A CANAL PROPERTY

SEAT LIMIT STOPS

M20J S/N 24-0361 thru 24-0387, 24-0389 thru 24-0394, 24-0396 thru 24-0403, 24-0405 thru 24-0412, 24-0414, 24-0416, 24-0418 thru 24-0422, 24-0424, 24-0425, 24-0427 thru 24-0430, 24-0435, 24-0435, 24-0433

FIGURE 20-211-1

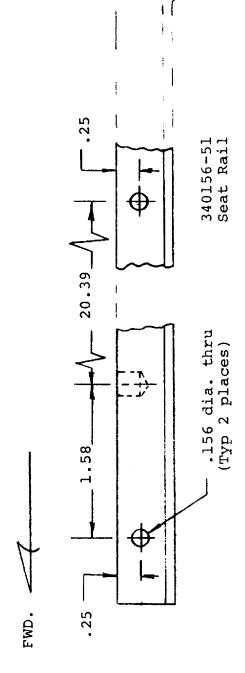
To prevent the possibility of the pilot and copilot seats coming off the seat rails during adjustment, the following modification should be accomplished:

- a) Remove the four cotter pins from the forward and aft end of the two inboard seat rails (340156-49).
- b) Remove the pilot and copilot seats.
- c) Drill 2 each .156 dia. holes in each outboard seat rail (340156-51) as shown in Figure 20-211-1, paying particular attention to the .25" dimension.

NOTE: Do not use existing holes as reference.
- d) Replace seats.
- e) Install AN 380-5-3 cotter pins in each newly drilled hole, 4 places.
- f) Fill out log book and return compliance card.
